Docket Number 50-346

October 20, 1995

Subject: Response to Request for Additional Information on Individual Plant Examination Submittal, Davis-Besse Nuclear Power Station, Unit 1 (TAC NO. M74402)

Figure 1-7. Event Tree for Sequences Initiated by a Small LOCA

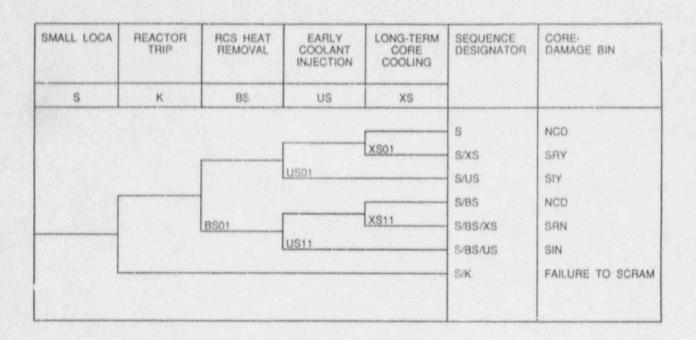
By letter dated September 11, 1995, (Toledo Edison Serial Number 2322) Toledo Edison (TE) responded to a Nuclear Regulatory Commission request for additional information (RAI) regarding the Davis-Besse Nuclear Power Station Individual Plant Examination (IPE). In responding to NRC Question 7 of the RAI TE inadvertently attached a transient event tree instead of the proper small Loss of Coolant Accident (LOCA) event tree (Attachment 3, Figure 1-7, to the RAI response). By attachment to this letter TE is providing the proper event tree for a small LOCA.
